## Town of Medley

Date:	<b>April 18, 2015</b>
Subject:	<b>ITB FOR DANNY MEEHAN RECREATIONAL FIELD IMPROVEMENTS PROJECT</b>
Solicitation Number:	<b>ITB 2015-001</b>
OCPDS Number:	<b>PR-1301</b>
Opening Date / Time:	<b>April 22, 2015 at 3:00 PM</b>
ADDENDUM Number:	<b>4</b>

Attachment **A4-01(b)**

**Bid Questions**

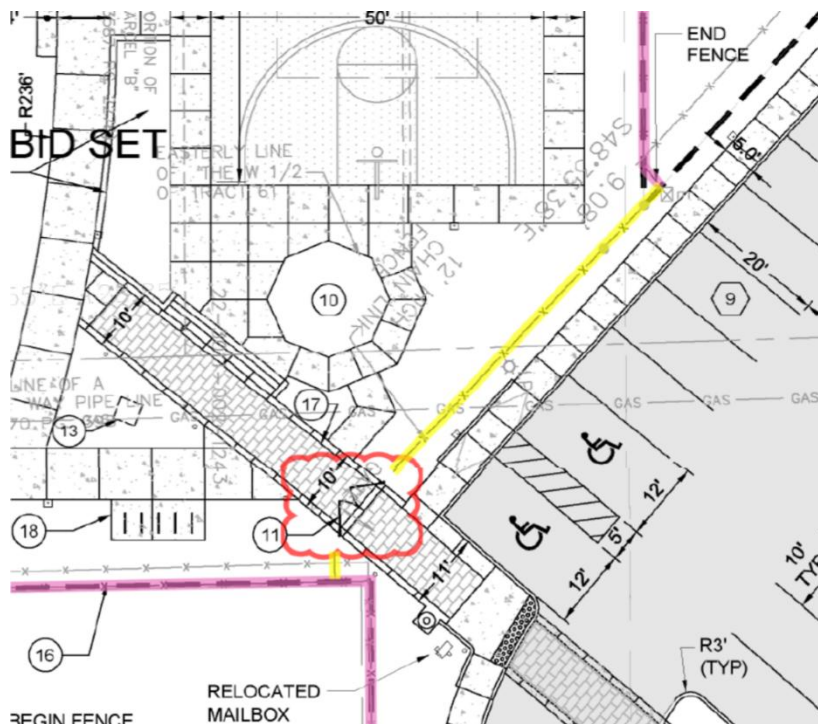
26. The electrical drawings call for Quazite pull boxes with traffic covers, however, Quazite does not offer traffic covers. Please clarify whether Quazite pull boxes can be installed with regular covers or a pull box should be installed with traffic cover. Please see attached from Quazite.

Refer to attached web link indicating specified handhole with traffic rated cover. (RBJ-SCEI).

*Figure 2- L201*

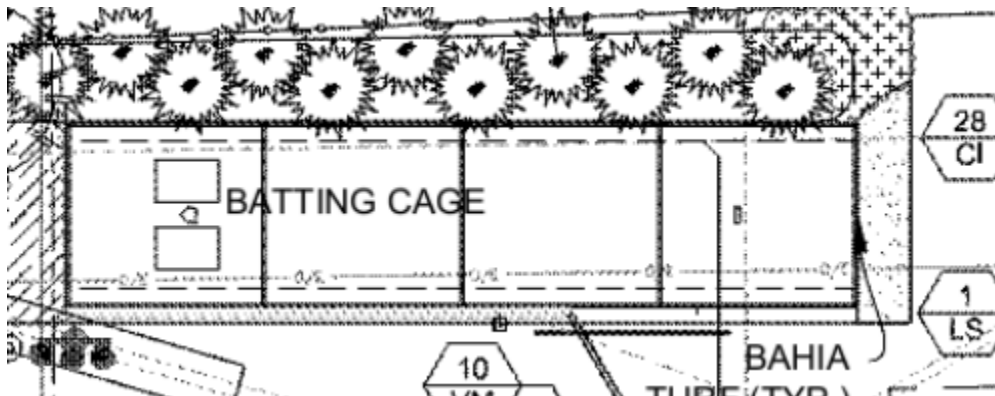
37. The existing playground that is to have recycled matting requires a 4" concrete base underneath the matting. Plans do not indicate any base. Is the base and the matting existing?
38. The plans do not indicate the type of floor for the batting cage. Will the batting cage floor be sod, asphalt or concrete? Please advise.

Figure 3 - C-200

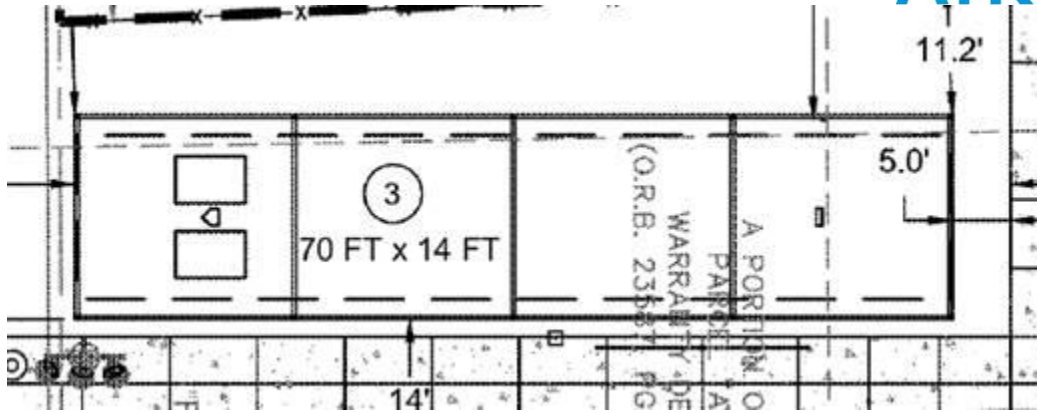
36. Plans keep on referring to Architectural Drawings, however there are none. Please advise.

2. SEE ARCHITECTURAL SITE PLAN FOR FIELD / COURT DIMENSIONS, LAYOUT, BRICK PAVER DETAILS, AND DETAILS.

*Please refer to Landscape Architectural drawings L series.*

Figure 4 - Detail 1/L151

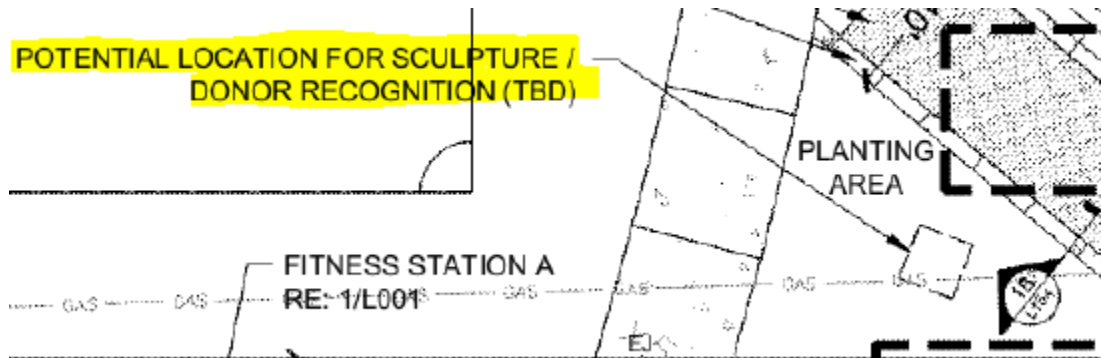
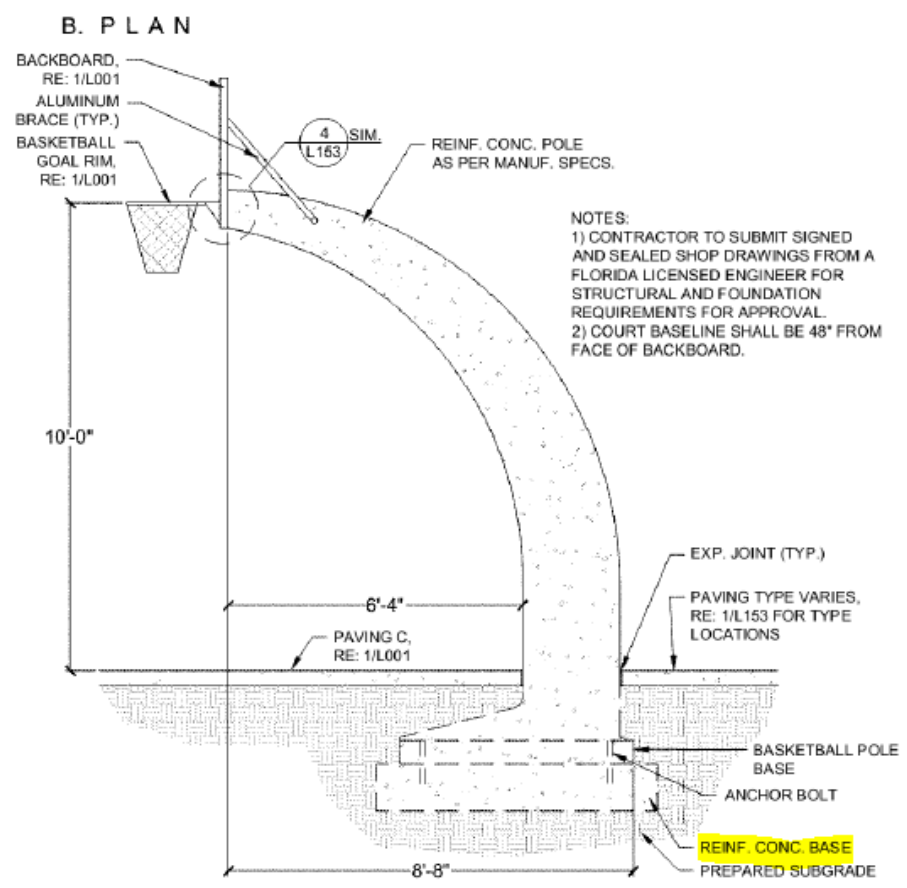
39. L101 indicate that the soccer goal are NIC. Please verify if this true.
40. Detail 1/L151 makes a reference to a potential location for sculpture/donor recognition (TBD). Will a footing be required?

*Figure 5 - Detail 3/L153*

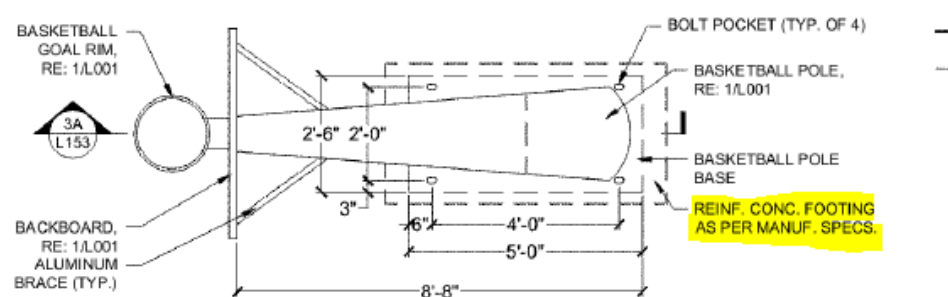
41. Detail 3/L153 references the pre-cast reinforced concrete pole for the Basketball courts, however it does not indicate any footings required for this pole (LXWXDepth). Please advise if we are to engineer taking into consideration hurricane forces, etc.

Figure 2- L201

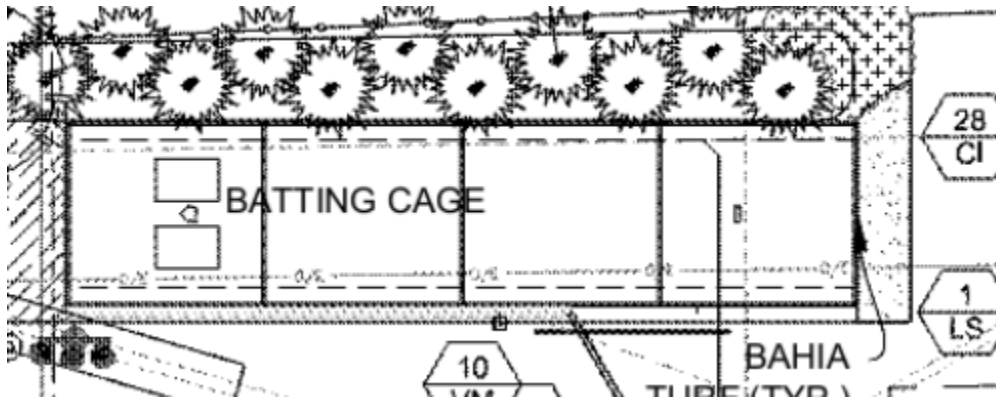
39. The plans do not indicate the type of floor for the batting cage. Will the batting cage floor be sod, asphalt or concrete? Please advise.

*Design intent was to replace existing batting cage which has a sod floor*

Figure 4 - Detail 1/L151

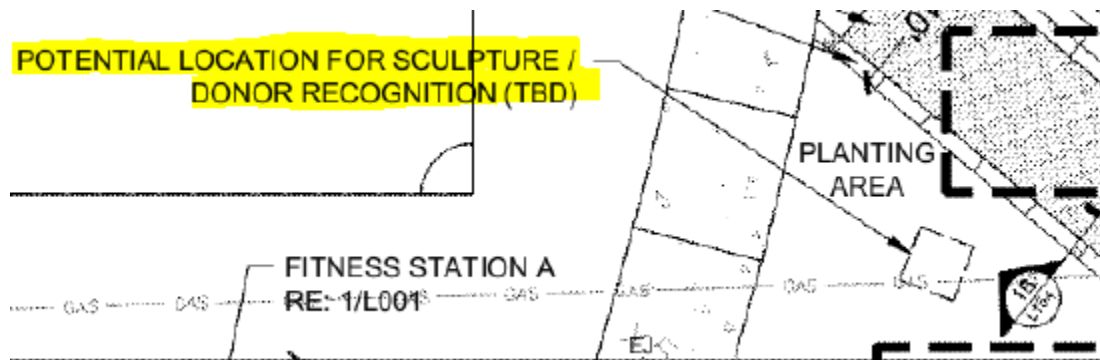
41. Detail 1/L151 makes a reference to a potential location for sculpture/donor recognition (TBD). Will a footing be required?

*No Sculptor/ Donor recognition is within this contract. This is only a placeholder location for the city's future consideration*

Figure 5 - Detail 3/L153

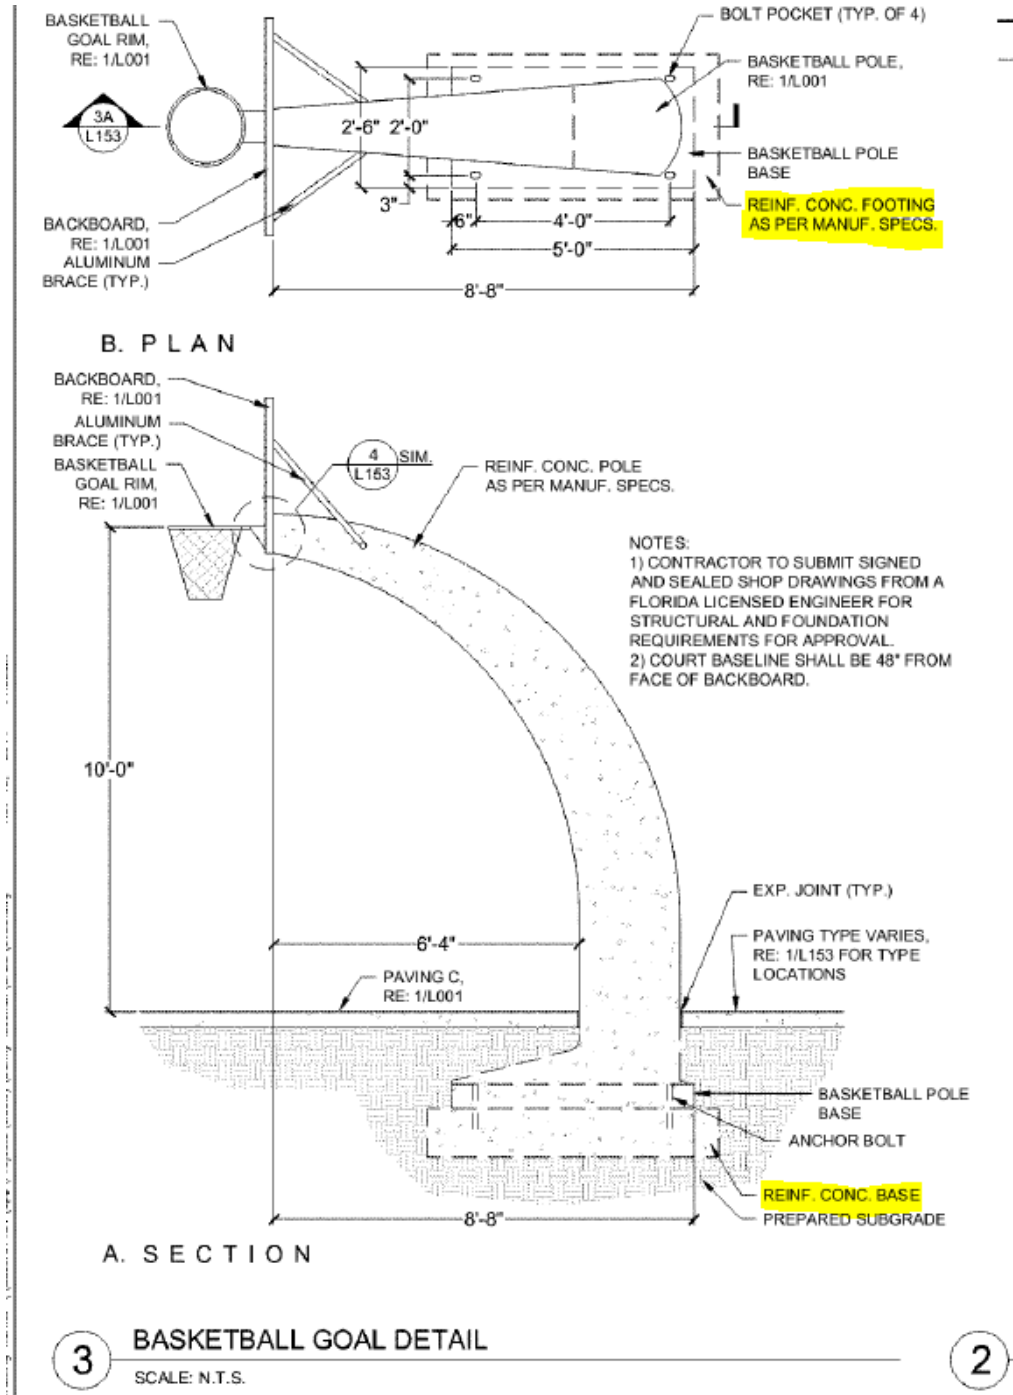
42. Detail 3/L153 references the pre-cast reinforced concrete pole for the Basketball courts, however it does not indicate any footings required for this pole (LXWXDepth). Please advise if we are to engineer taking into consideration hurricane forces, etc.

*Contractor to provide design for reinforced concrete footings using the latest edition of the Florida Building code with all it's ammendments.*
